Town of Arlington, MA Redevelopment Board

Agenda & Meeting Notice September 9, 2024

2. Public Hearing: Docket #3816, 5-7 Belknap Street

3. Public Hearing: Docket #3633, 1500 Massachusetts Avenue

GROUND FLOOR AREA DIAGRAM - 8/26/24 PROPOSED UPDATES

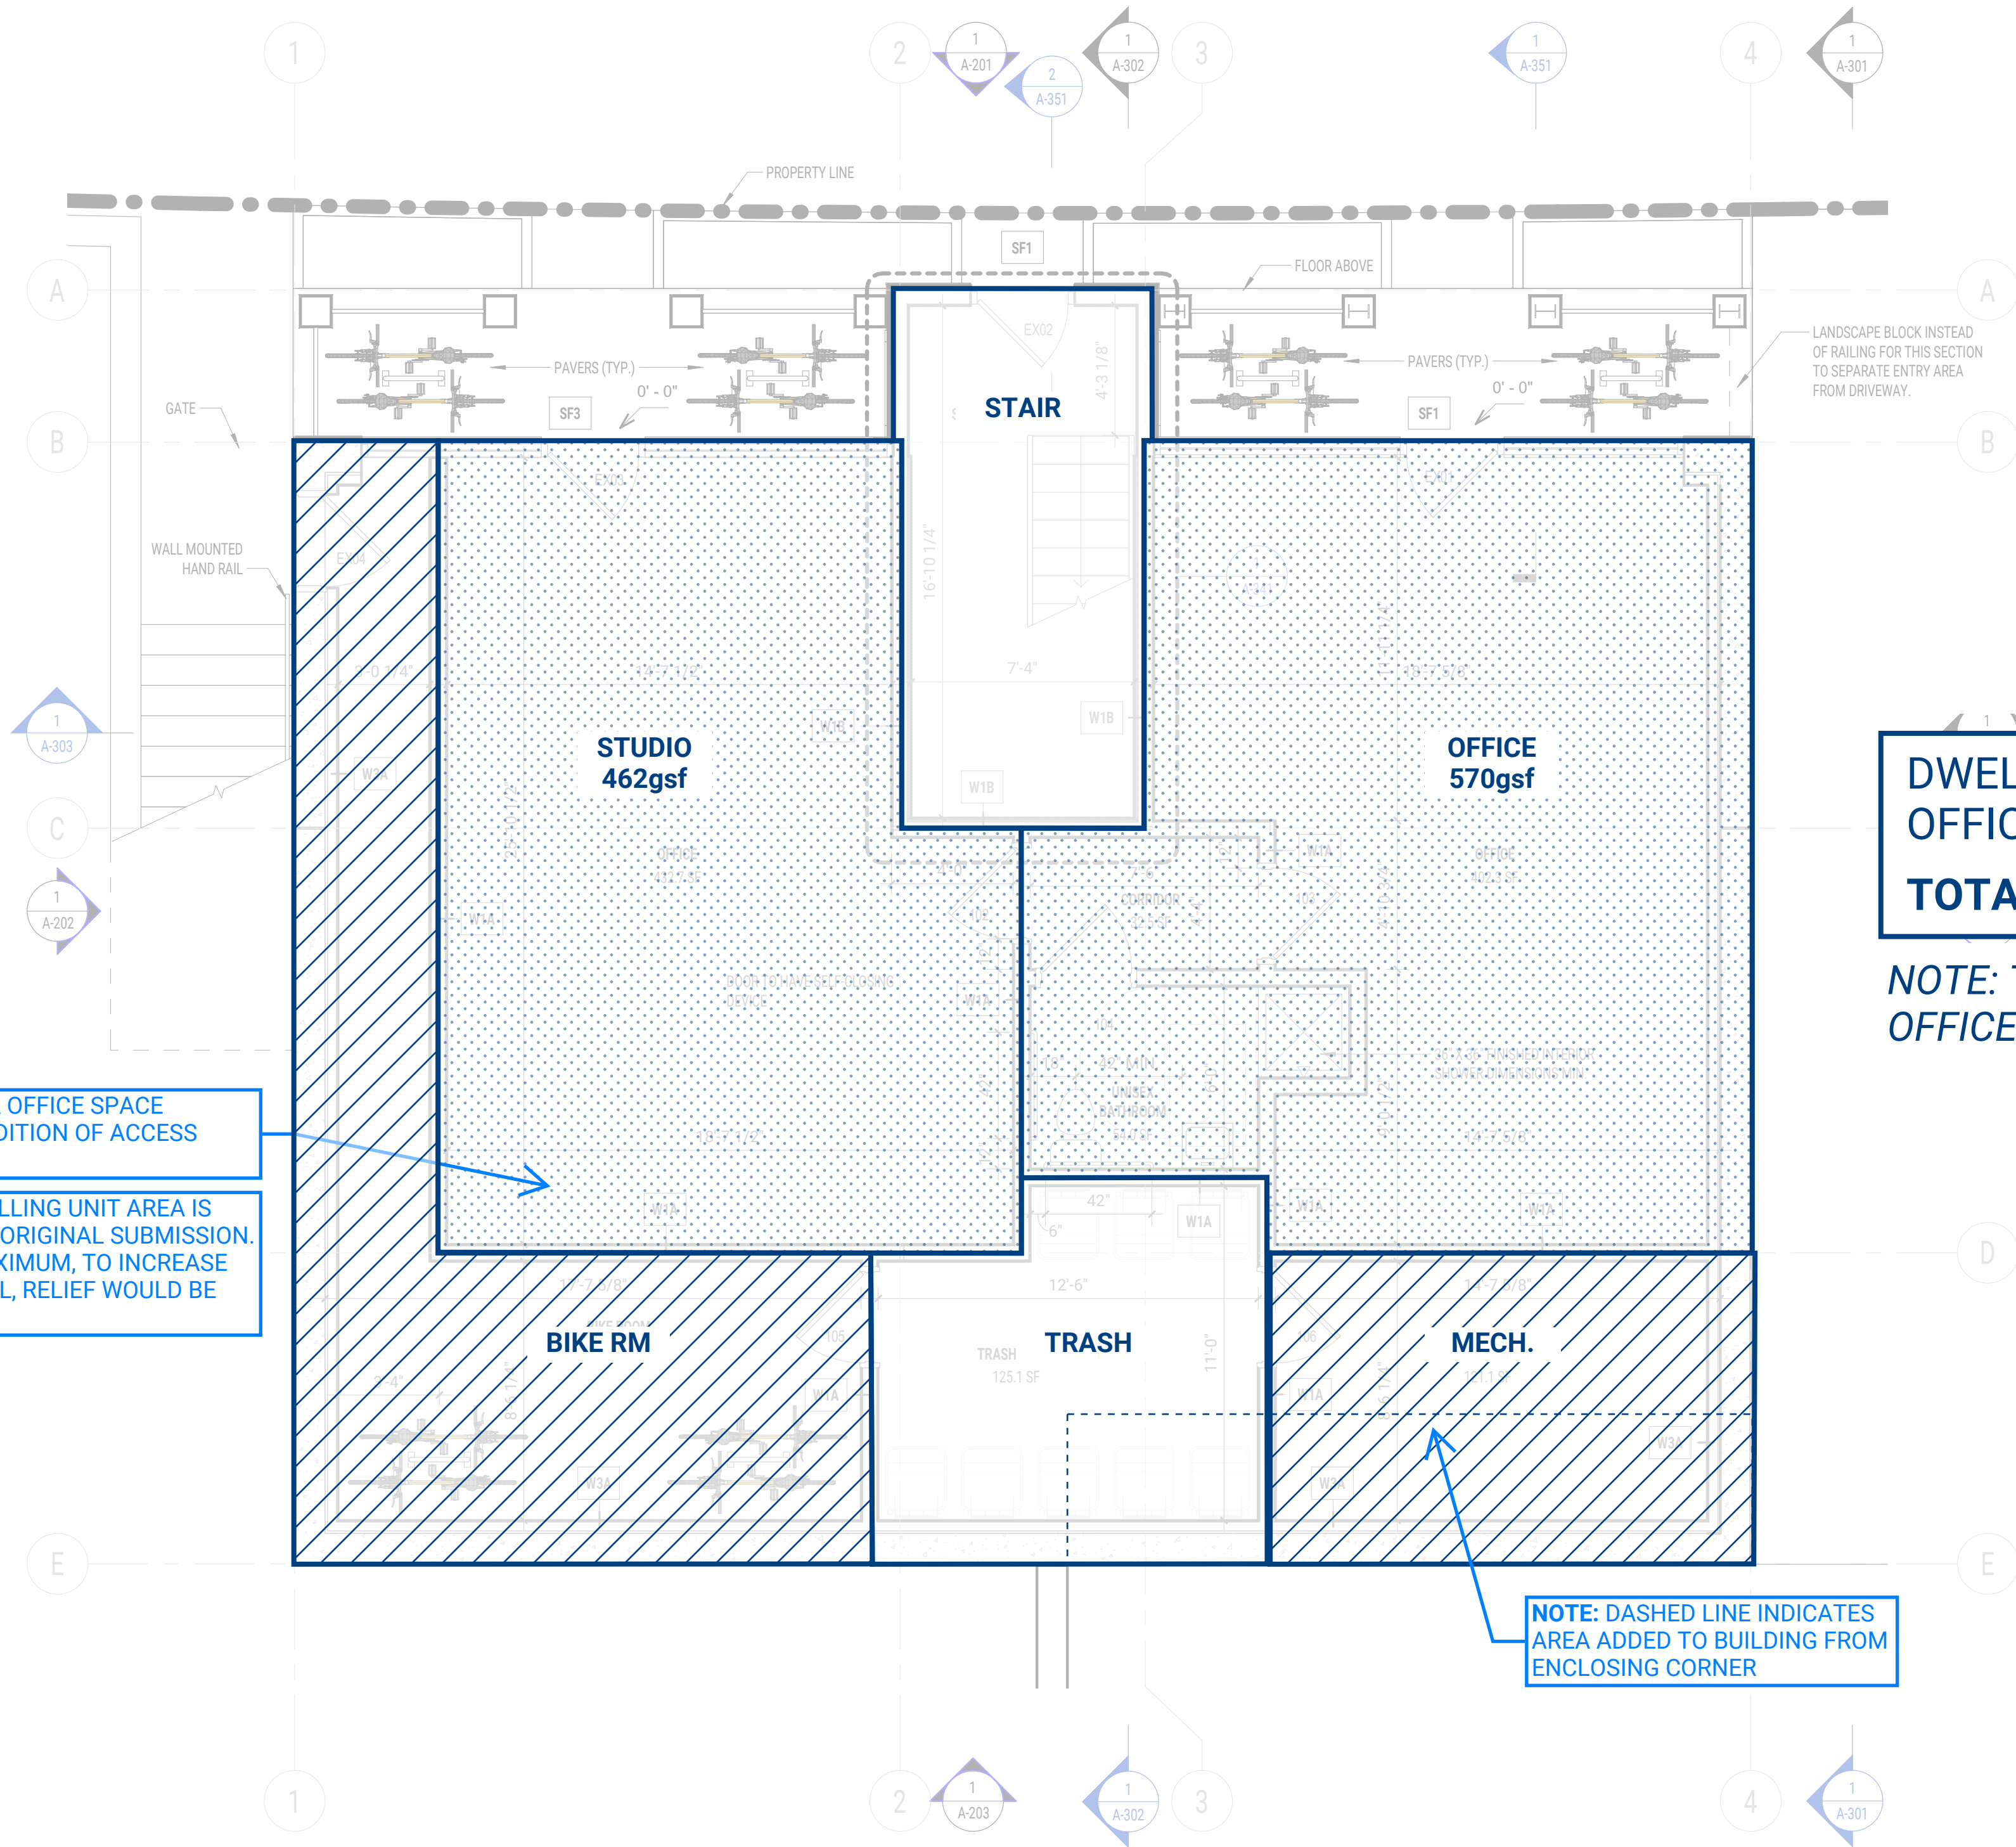
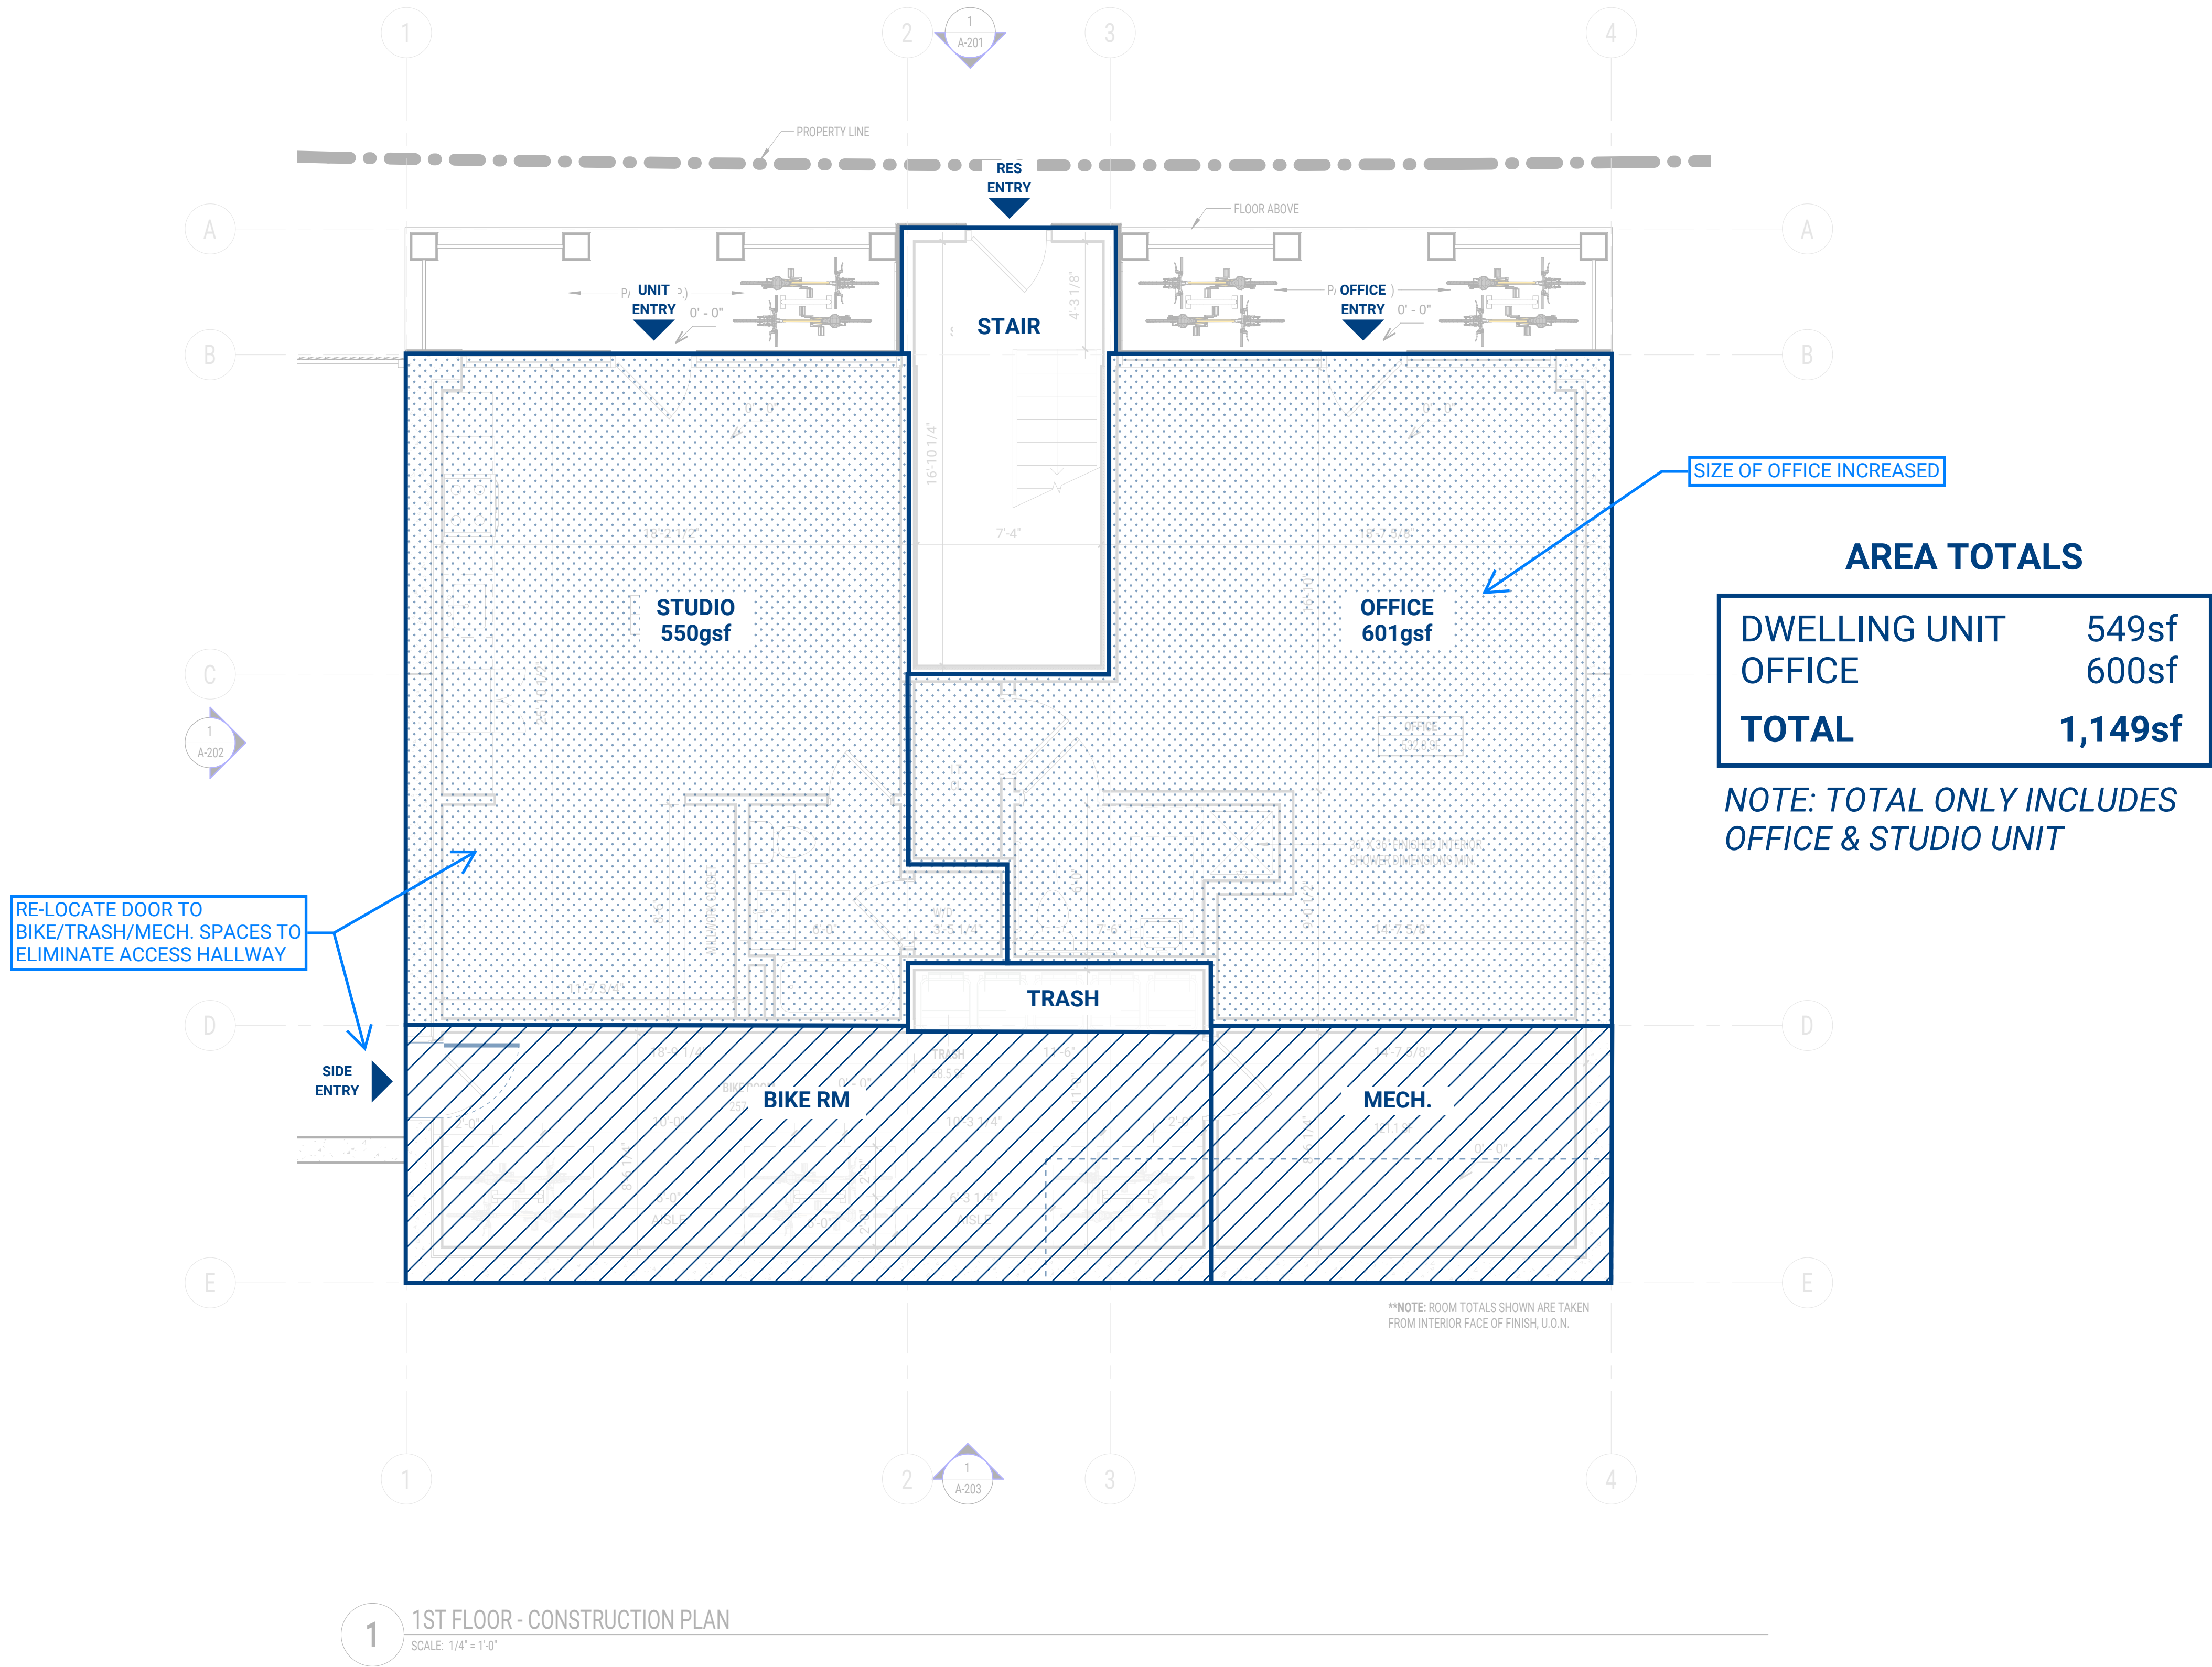
Diagram to show area totals at ground floor - this is the plan being proposed currently, and has incorporated comments discussed at the previous ARB hearing.

PARKING ACCESS STUDY

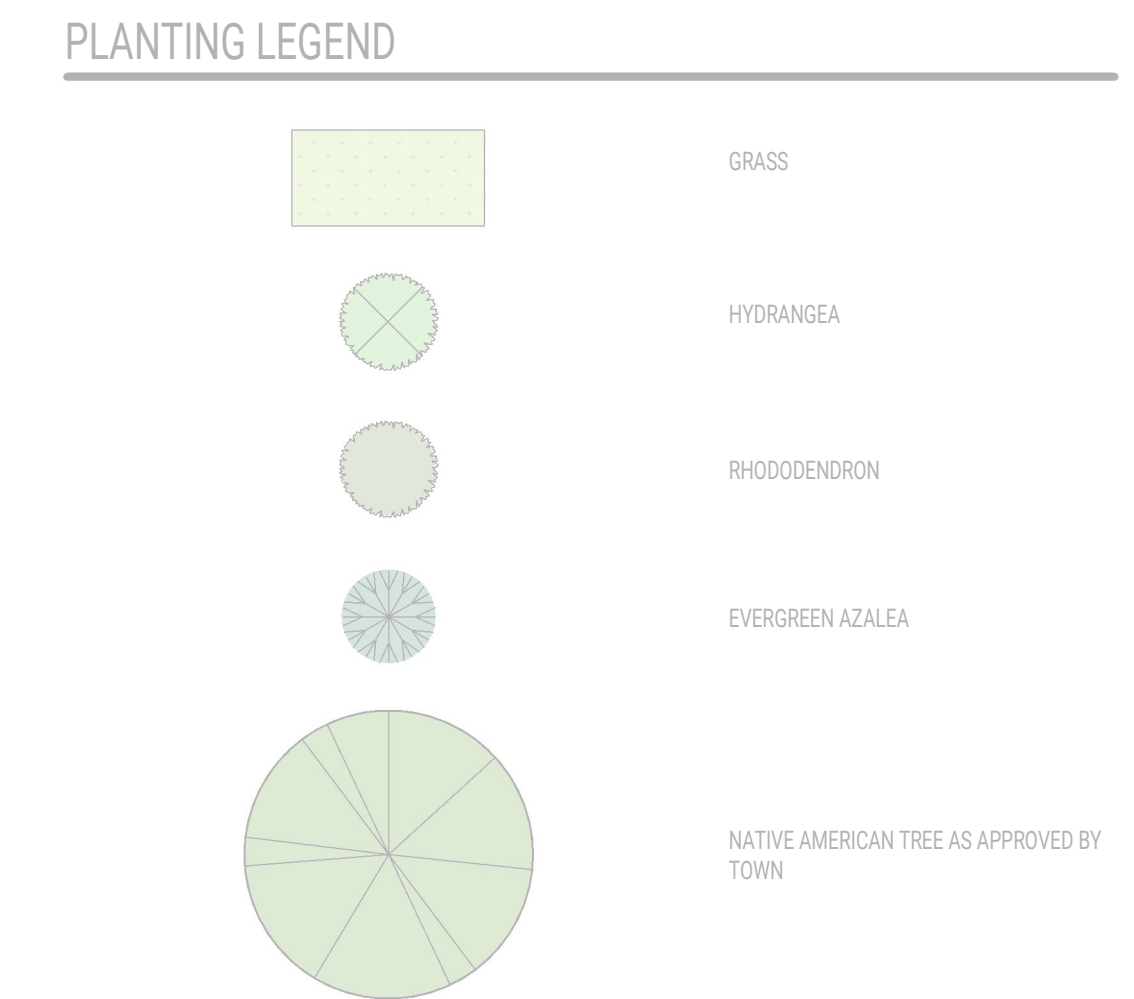
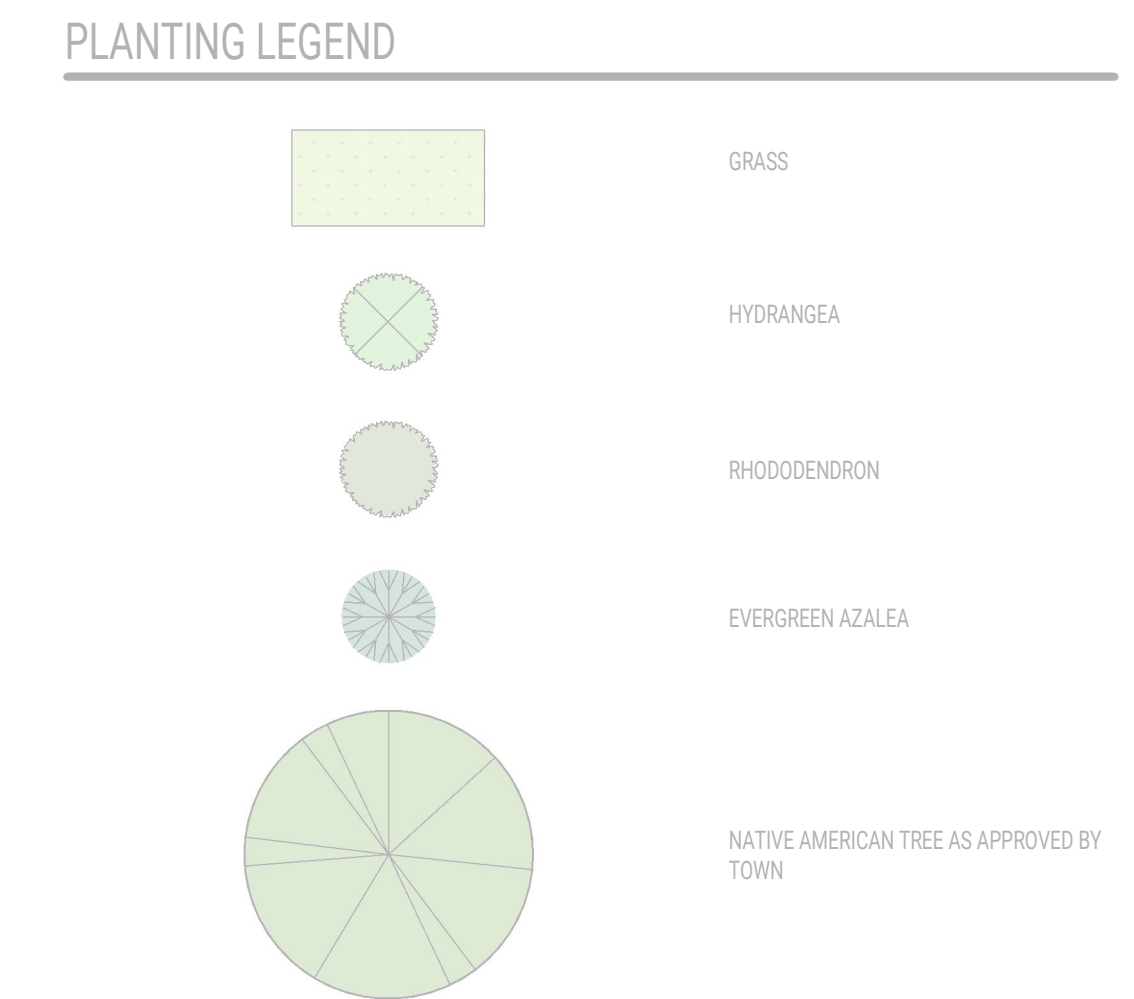
Diagram to show parking study - this study is being proposed per comments received from the ARB.
